सम्मिश्र जांच दल/ Composite Trials Team  
द्वारा नौसेना कार्यालय/ c/o Navy Office  
मुख्यालय/ Headquarter  
अन्डमान एवं निकोबार कमान/  
Andaman & Nicobar Command  
पोर्ट ब्लेयर ७४४ १०२/ Port Blair 744 102

CTT/300/04/04/TECH

### **HIGH VIBRATION ON PORT DA - INS KARMUK**

# INS KARMUK PORT DA AFE at 25% (load)

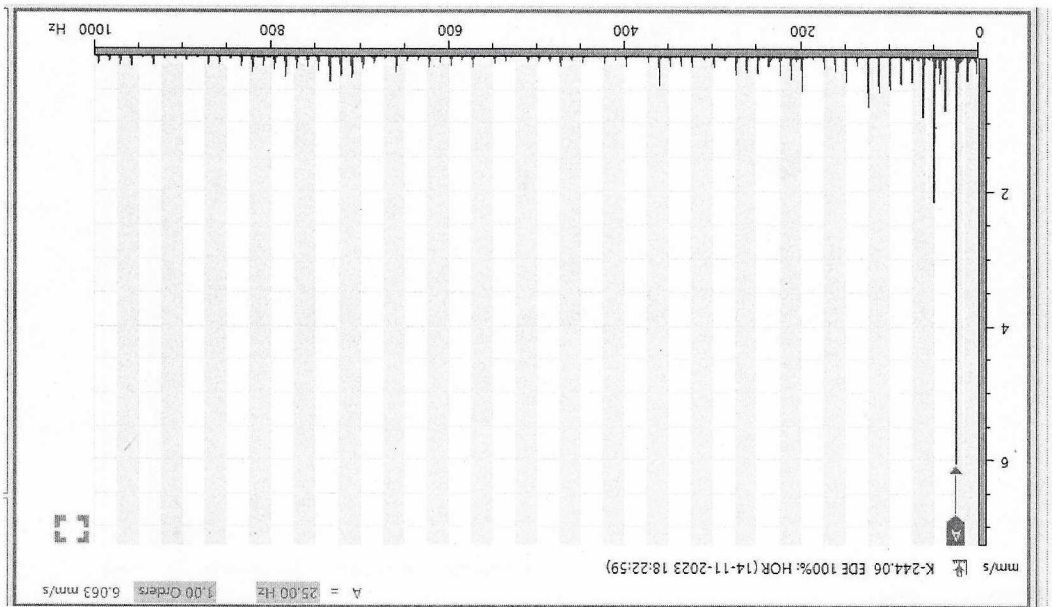
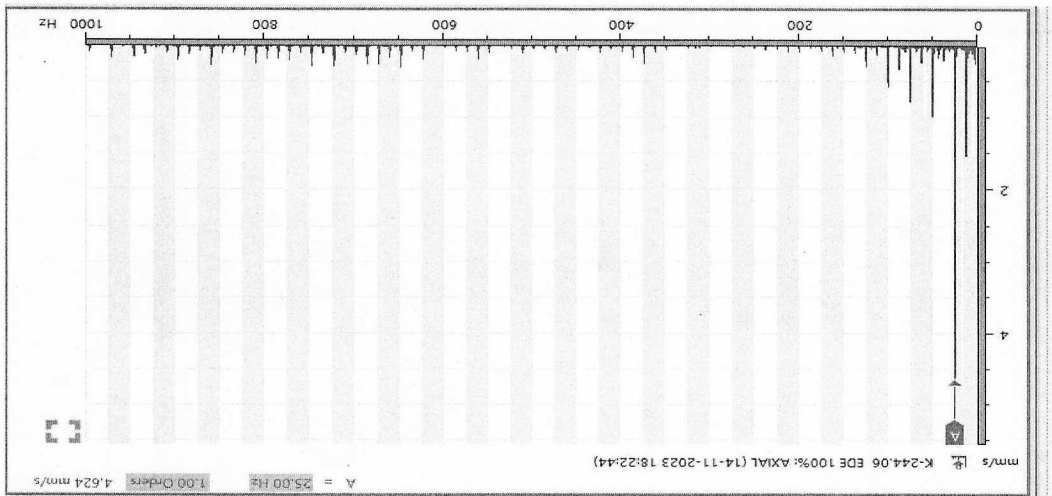
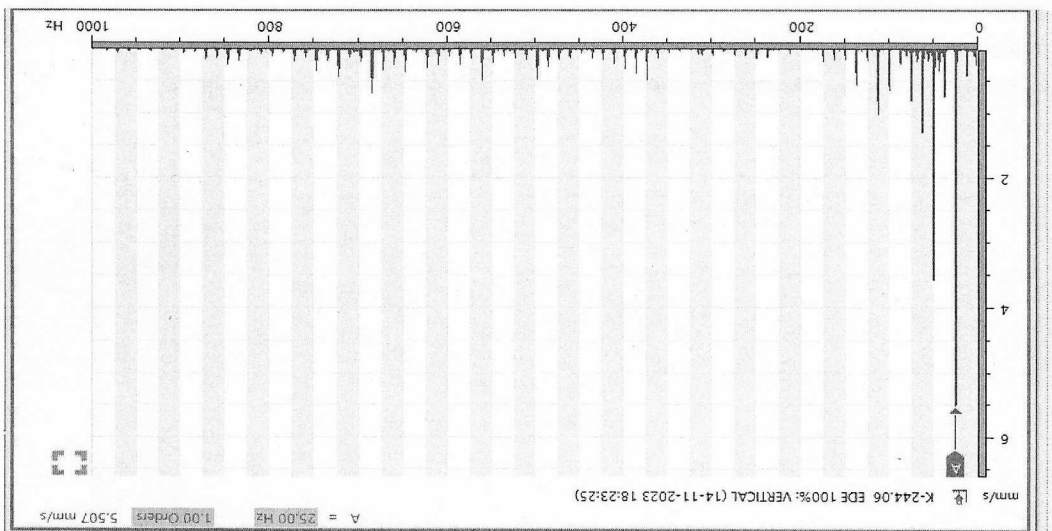
4. **Spectrum Analysis.** Narrow band/ Spectrum analysis of PDA was carried out at 25% load. The FFT spectrum indicates a prominent 1x peak on alternator free end (Horizontal & Vertical directions) and low amplitude in axial direction with a **maximum amplitude of 38.62 mm/s at AFE(H)**. Further, no side bands/ harmonics were observed, indicating the possible presence of **dynamic unbalance of rotor**.

- Dynamic balancing of Rotor.
- Replacement of all bolts in bearing hub as per specification.
- Provisioning of greasing pipes on **Alternator NDE for all DAs**.
- Replacement of alternator cooler rubber beading.
- Replacement of all rusted bolts in alternator and engine foundation.
- Details of mounts viz. date of manufacture, deflection readings etc to be forwarded to CTT(Pbr).
- Loosening of all jacking and aligning bolts as per laid down procedures.

# INS KARMUK PORT DA ADE at 25% (load)

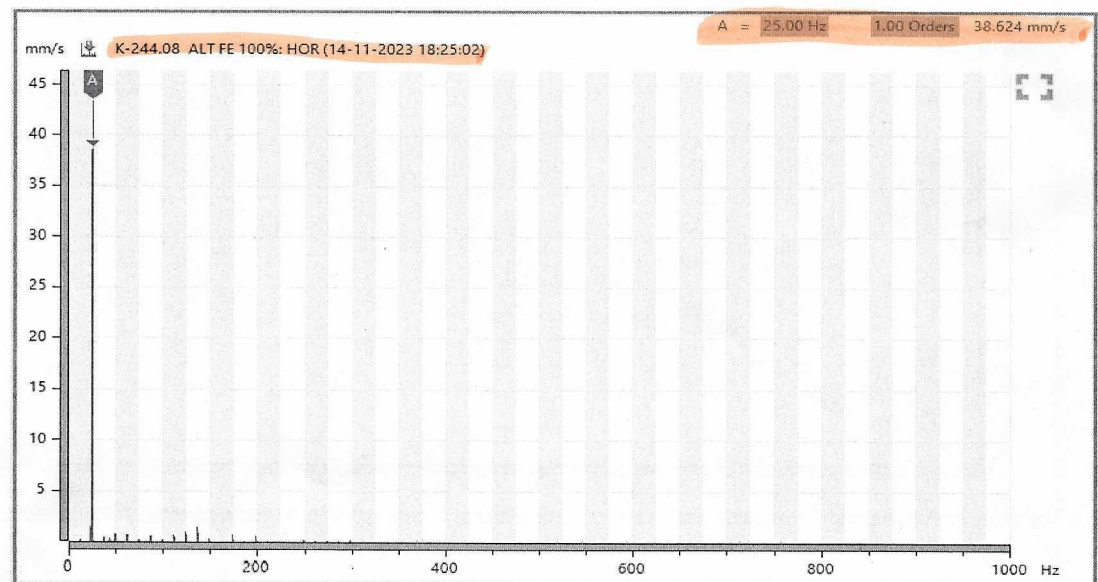
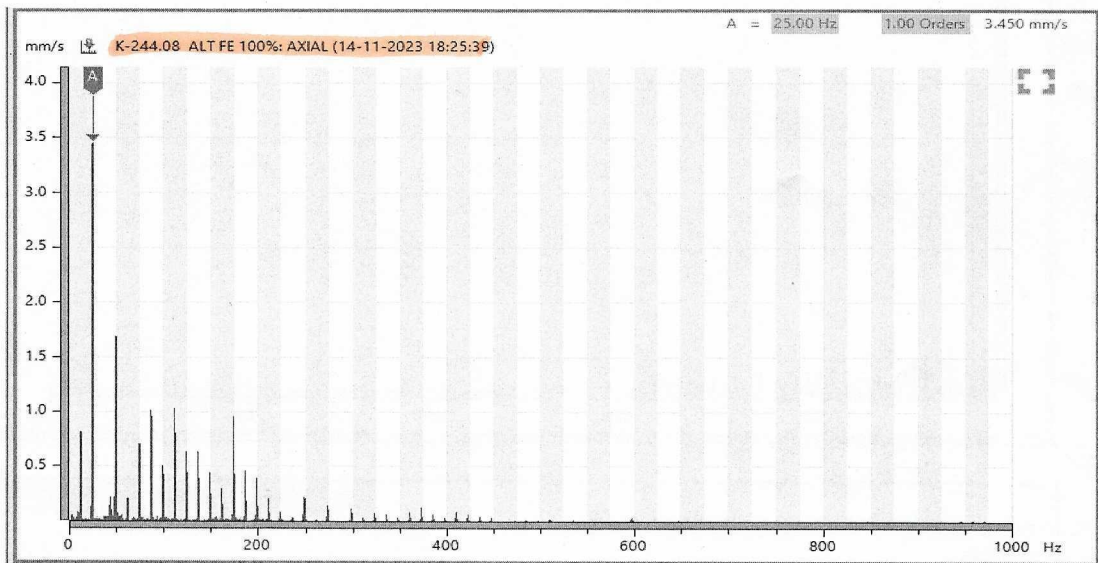
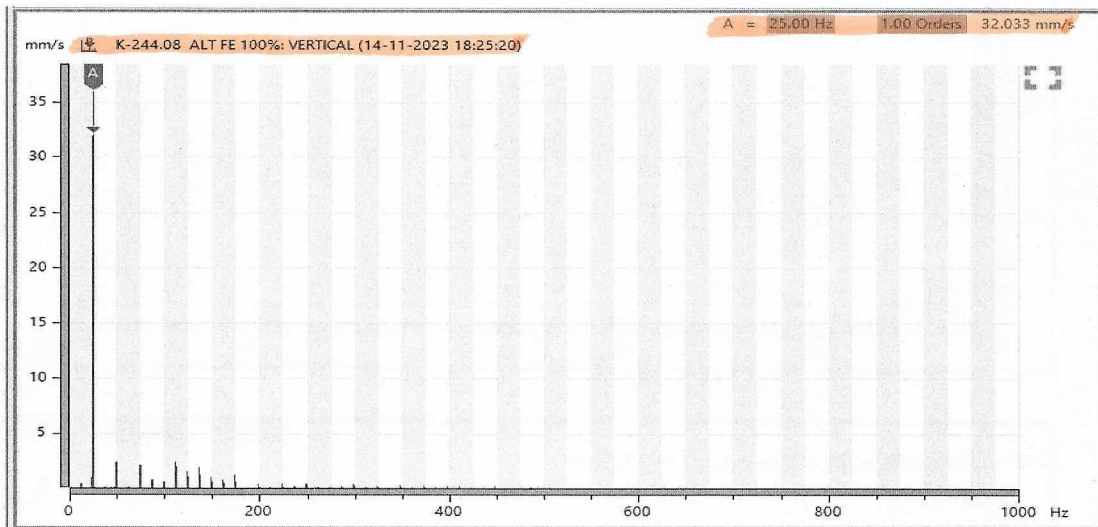
Ser.	Measuring Points	At 25% (87 kW) load			Remarks
		V	A	H	
(a)	Engine free end	8.17	6.61	6.54	Sat
(b)	Engine drive end	7.60	5.46	7.16	Sat
(c)	Alternator drive end	18.20	8.91	<b>28.82</b>	<b>UNSAT</b>
(d)	Alternator free end	<b>33.16</b>	4.81	<b>39.54</b>	<b>UNSAT</b>
